A New Fire Station for
Harmonville Fire Company – Plymouth Valley Station

DOCUMENT 00 9001 - ADDENDUM NUMBER 2 – 3/28/25

E
A8.01
PLAN DETAIL
1 1/2" = 1'-0"

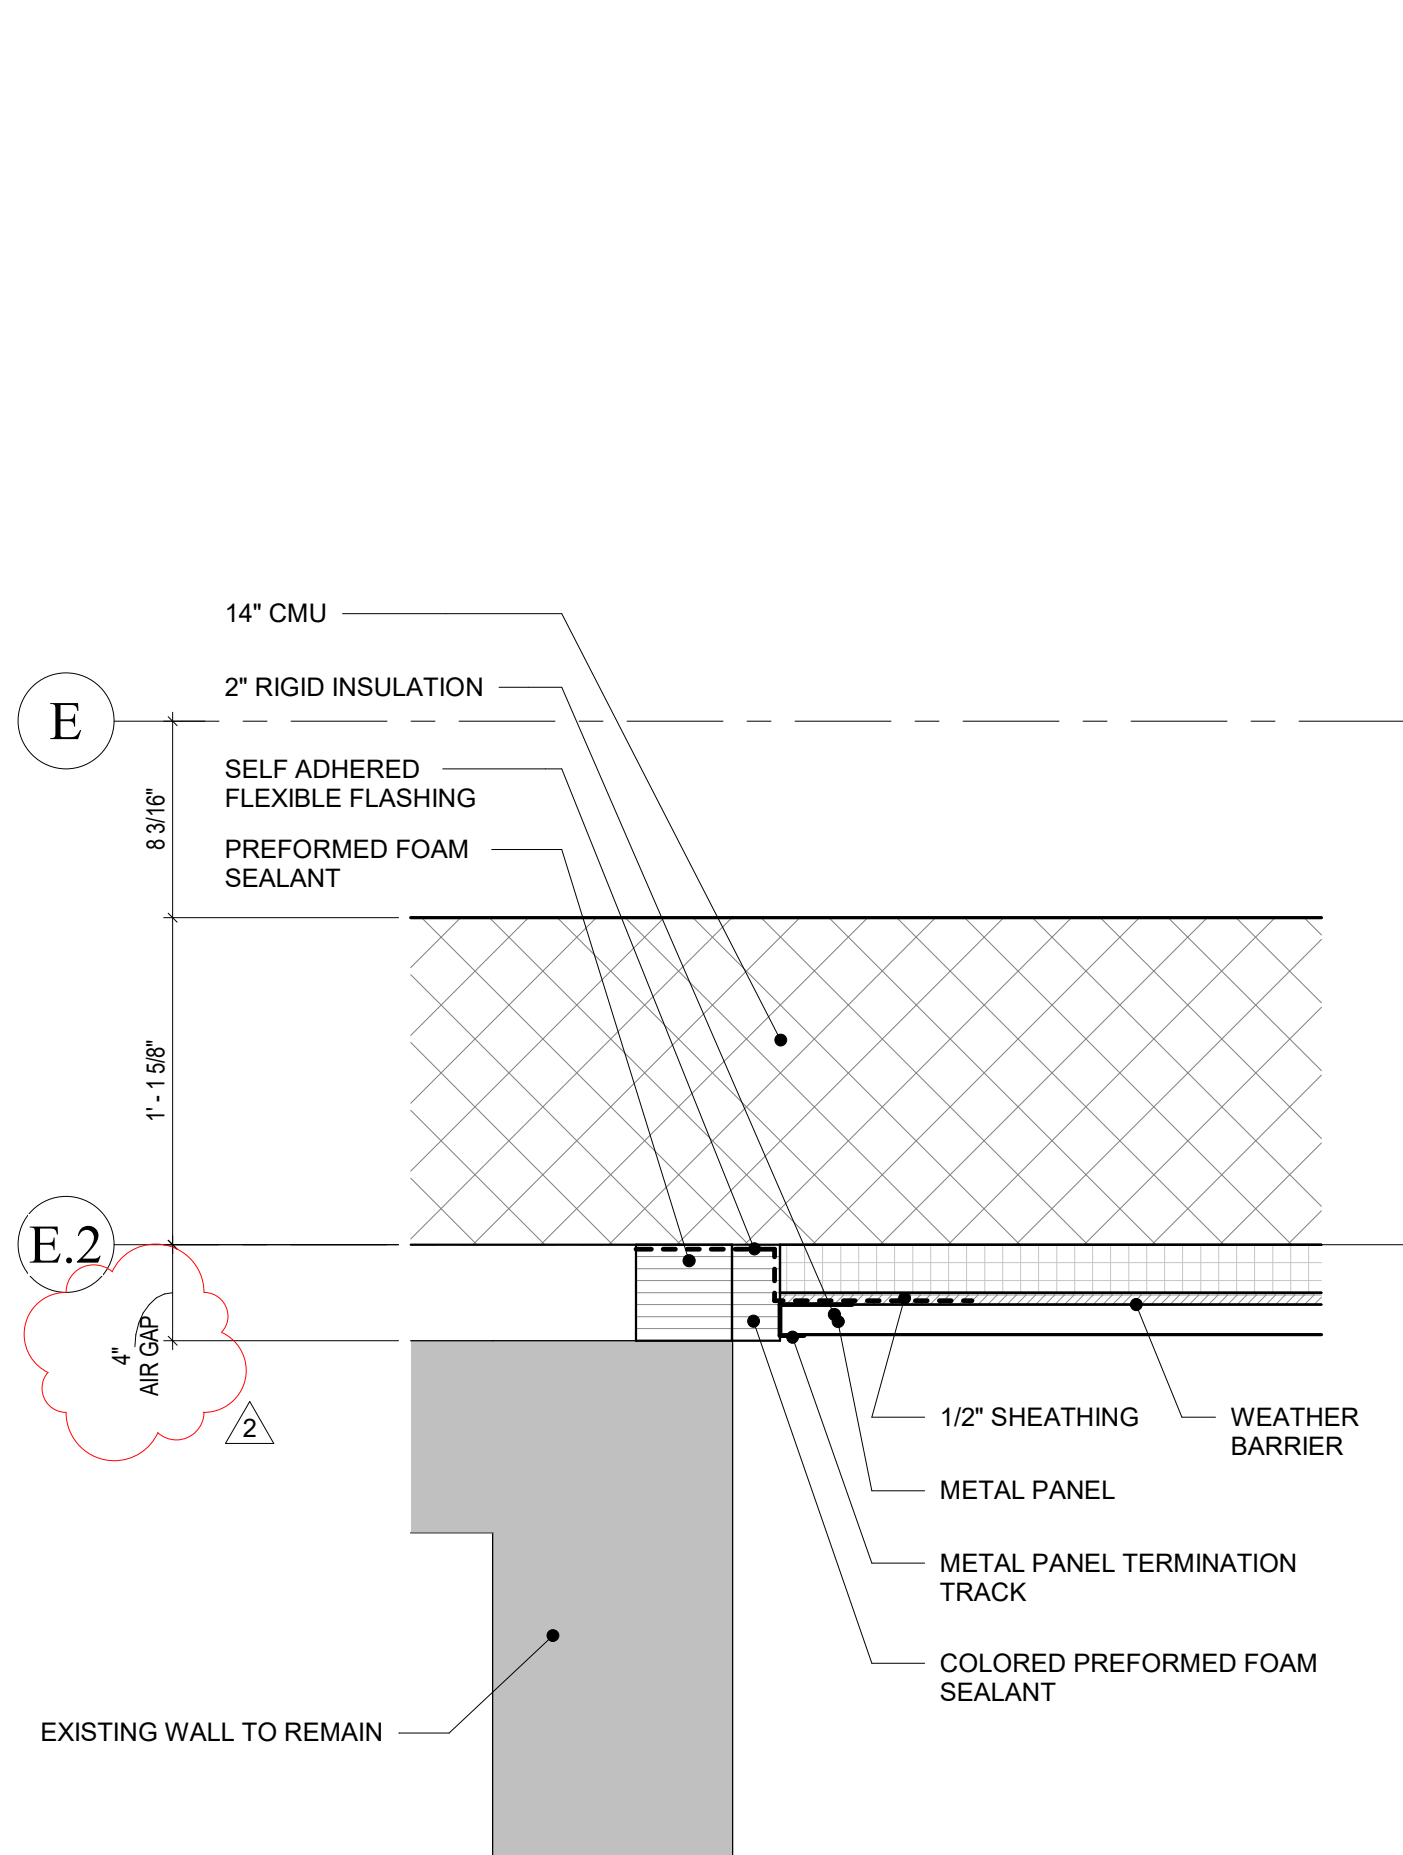
- 9001.14 Drawing sheet A8.01 Detail D and E have been updated to reflect the change of cmu thickness and placement.
- 9001.15 Drawing sheet A8.02 Detail J has been updated to reflect the change of the cmu thickness and placement.

REVISIONS		SHEET TITLE	
MARK	DATE	DESCRIPTION	
1	3/21/25	ADDENDUM 1	
2	3/28/25	ADDENDUM 2	
FOUNDATION		FOUNDATION	
JOB NO.		91242	
DATE		03/06/2025	
SHEET NO.		S2.01

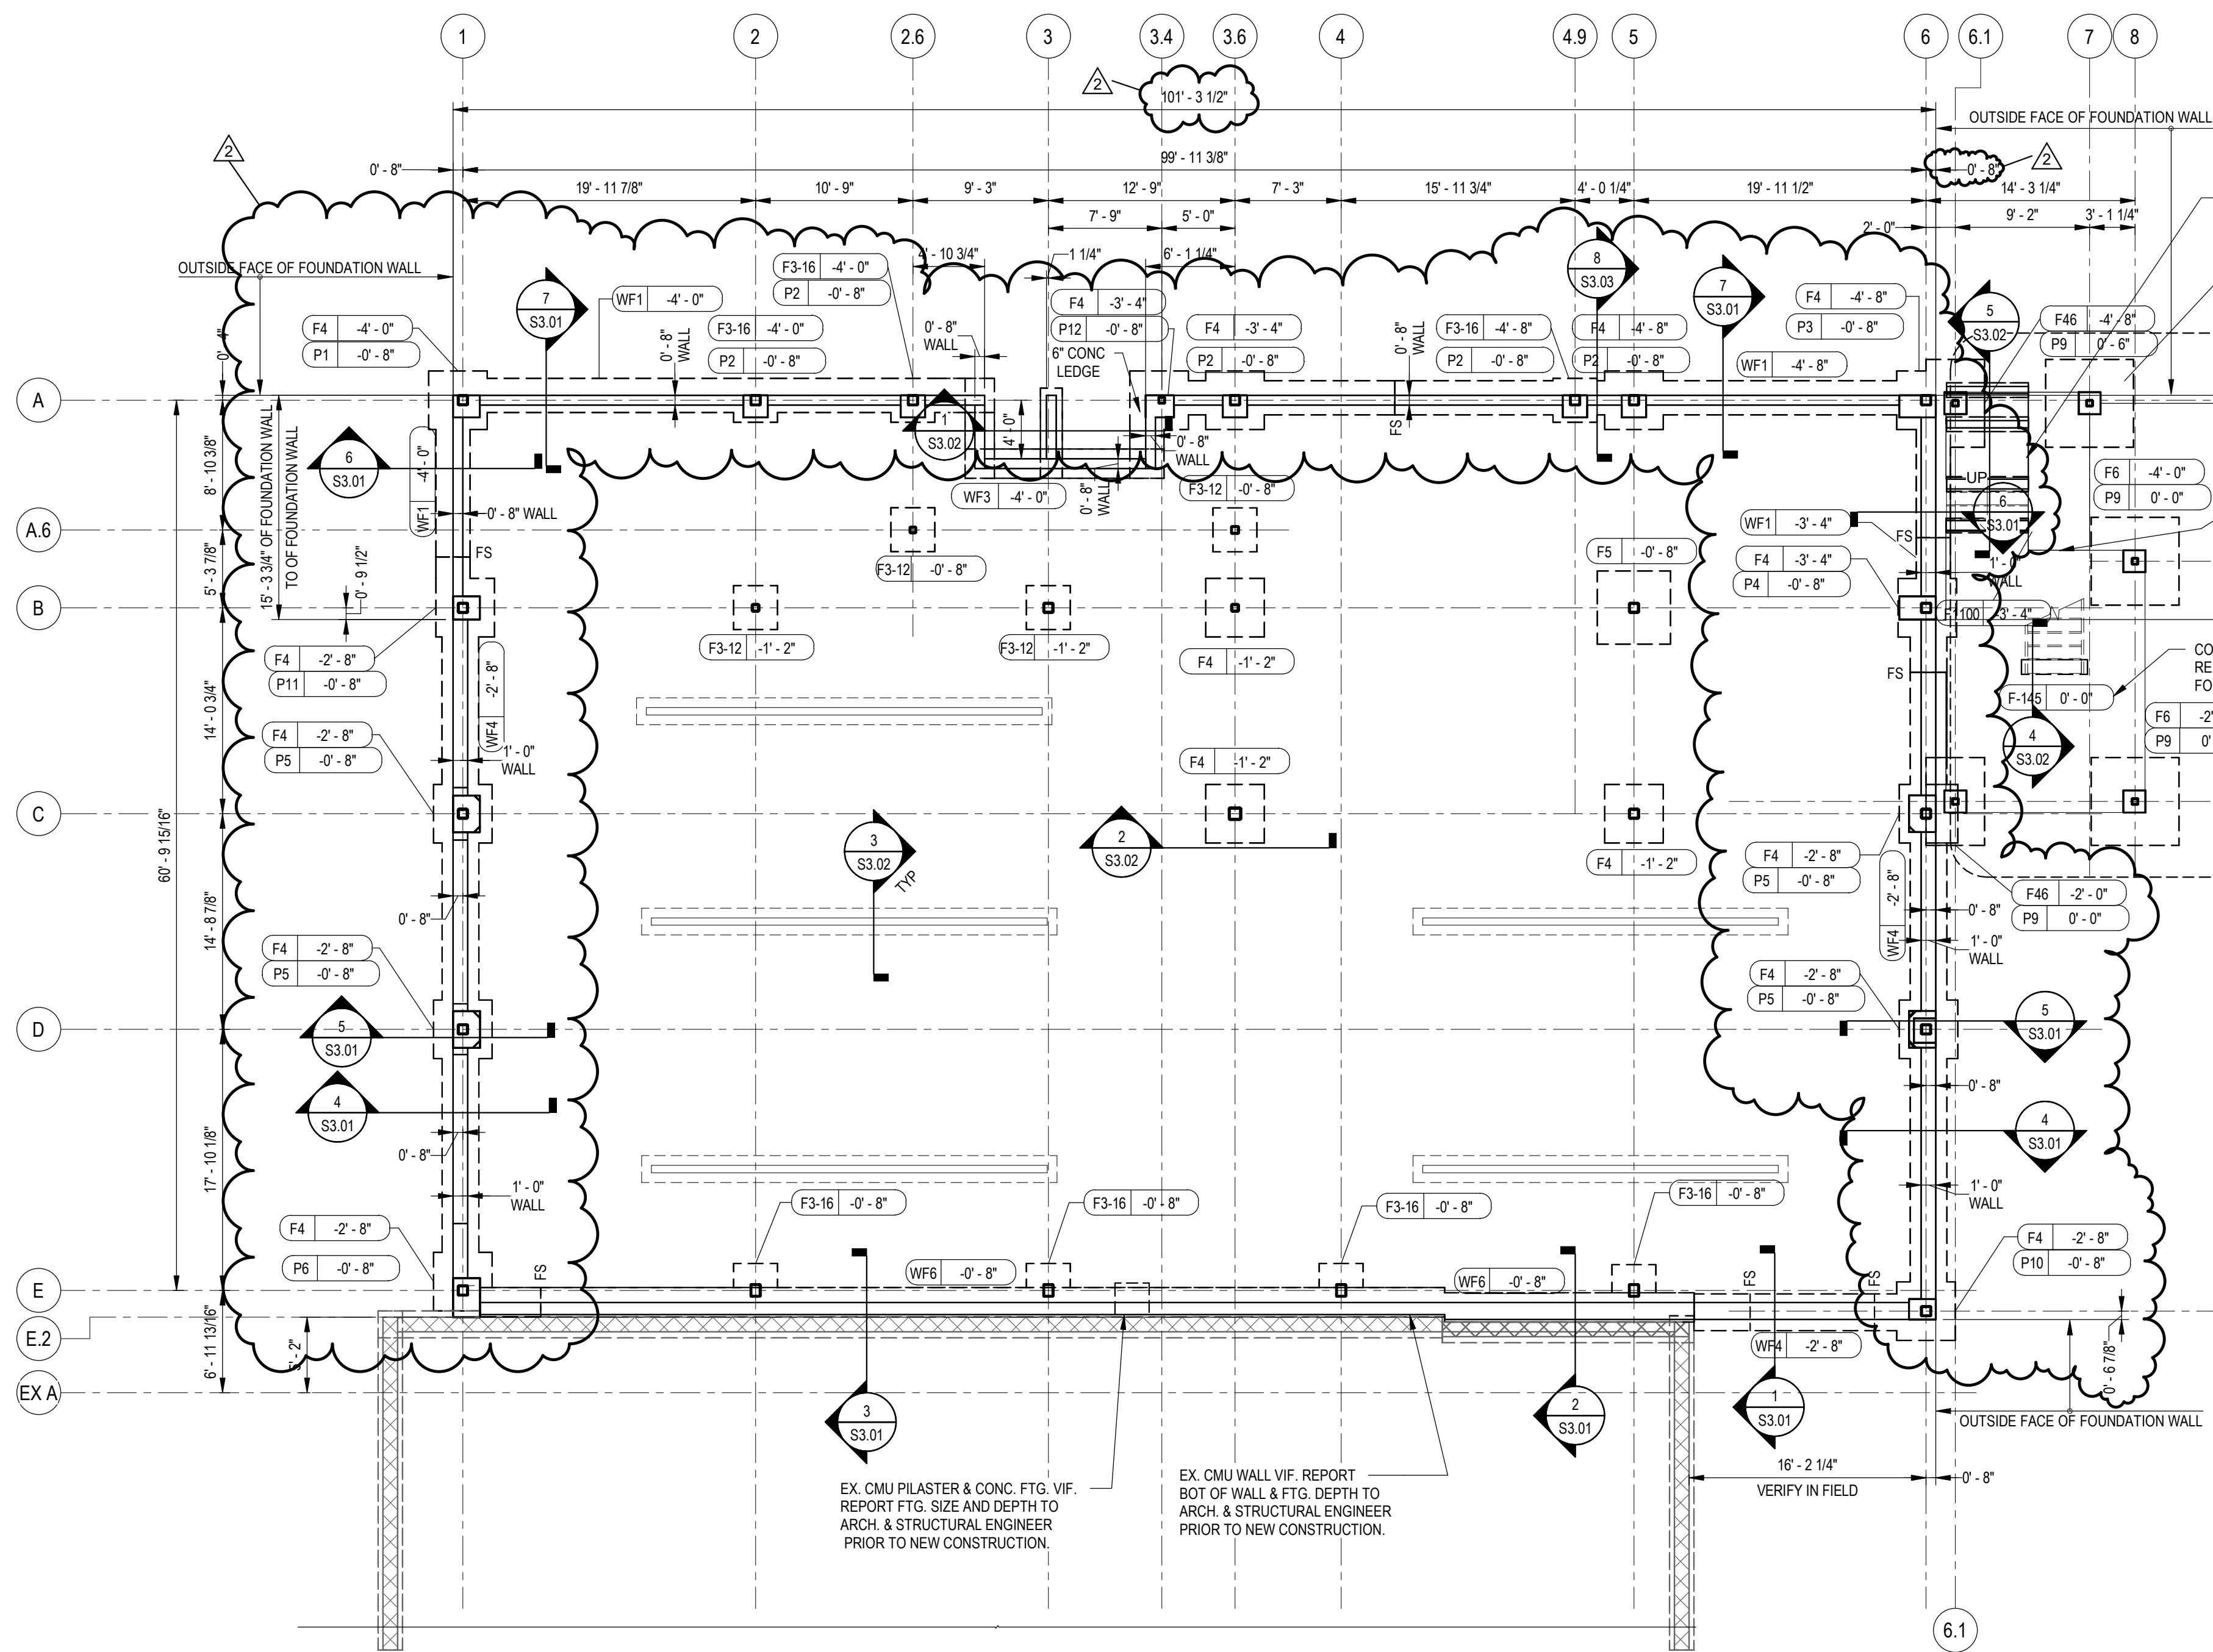
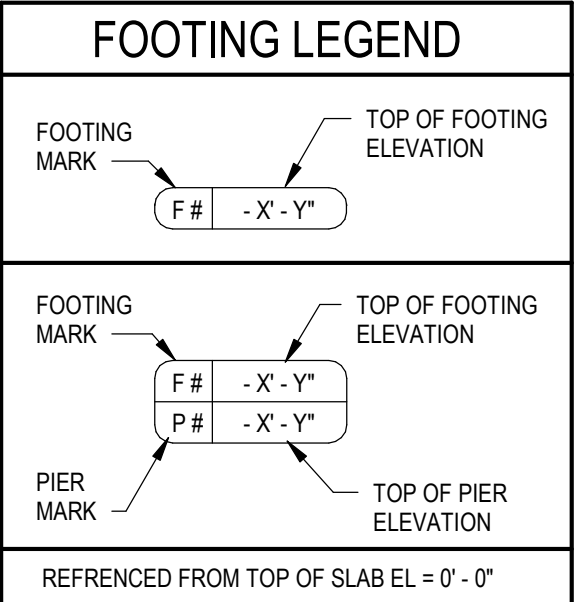
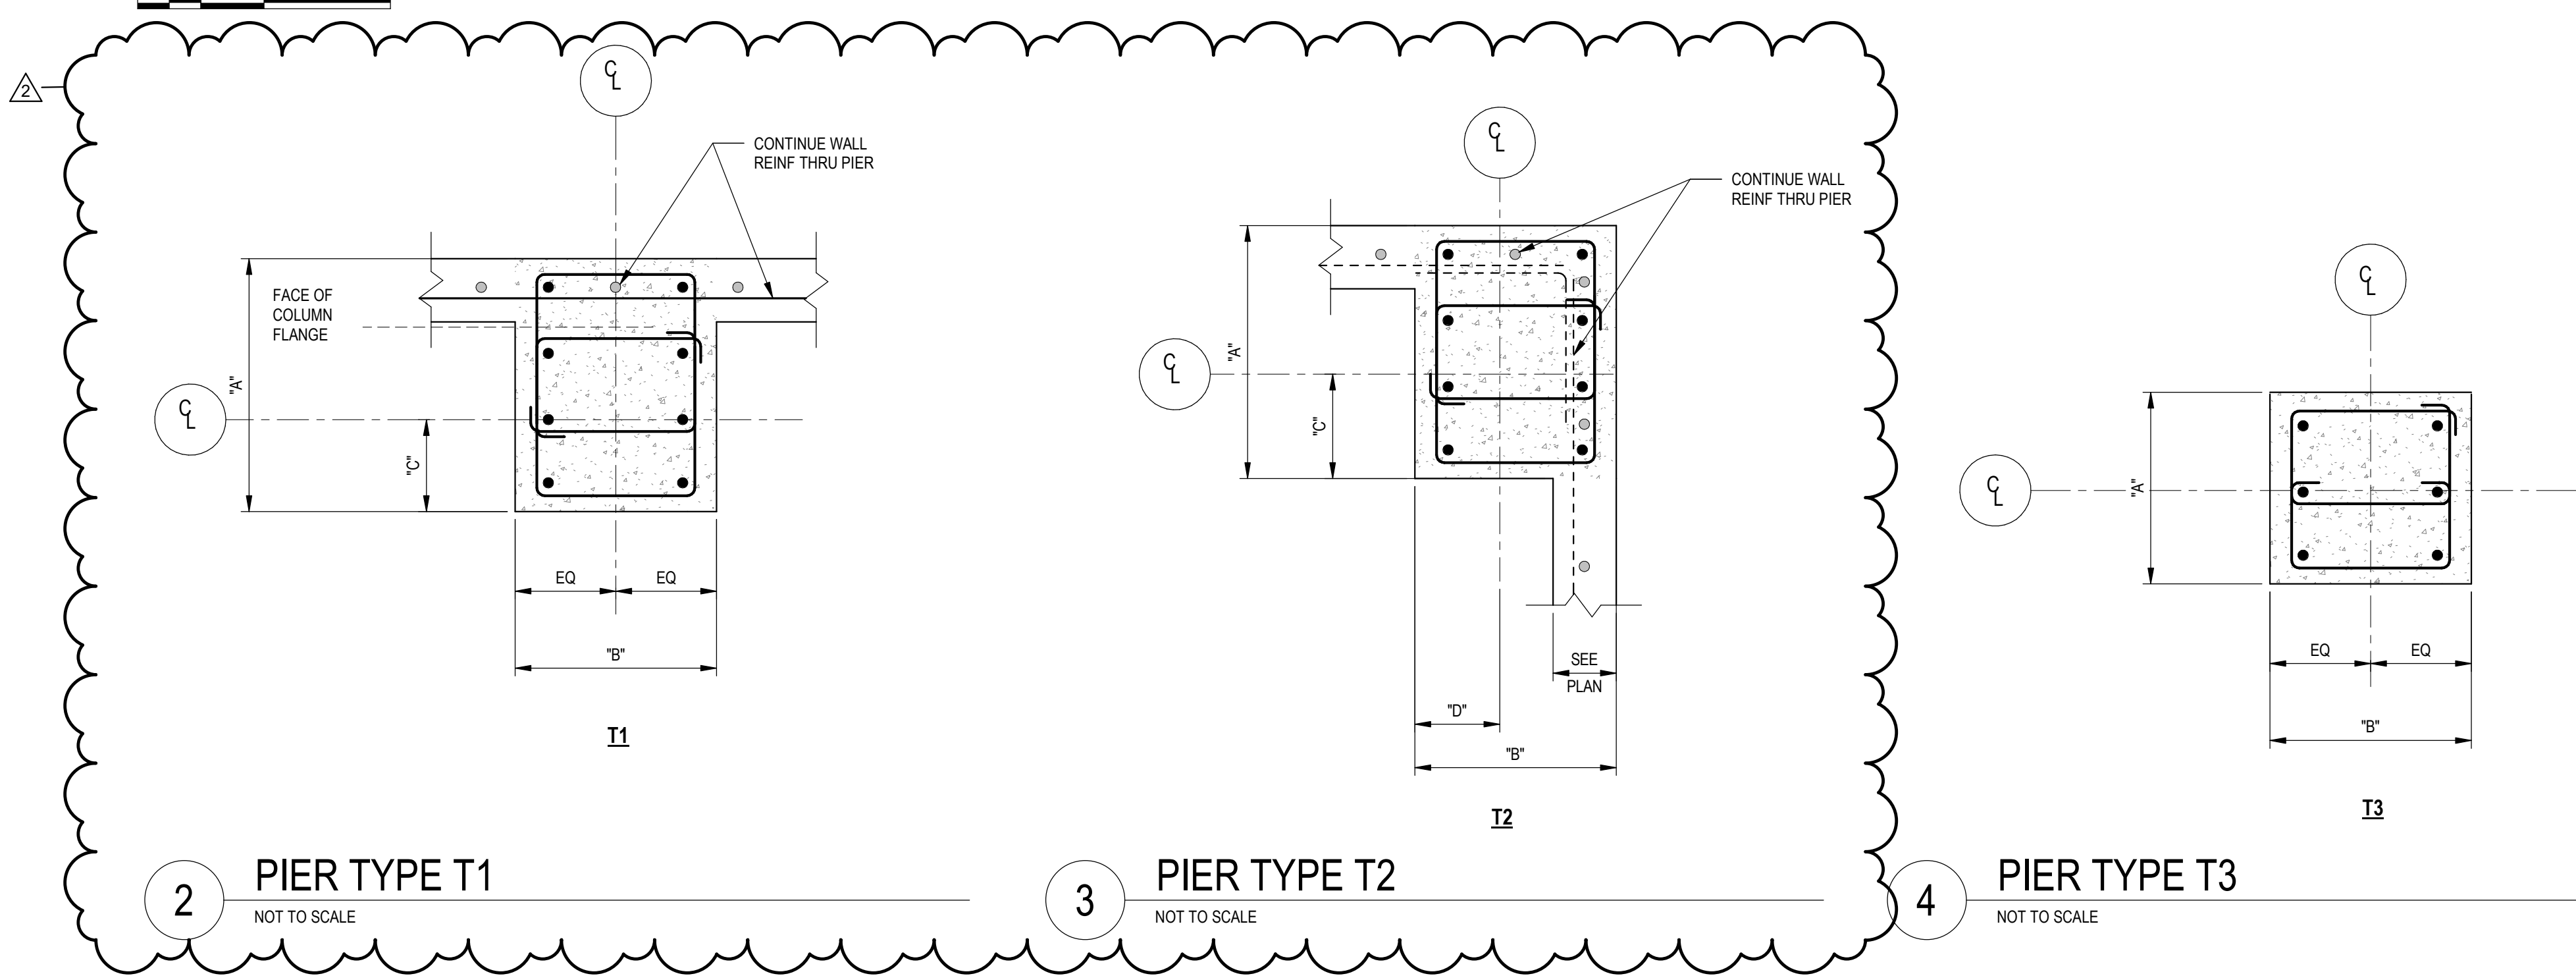
- 9001.18 Drawing sheet S2.01 has various updates related to the pier schedule and details.
- 9001.19 Drawing sheet S2.02 has an added note regarding the microsynthetic fibers.
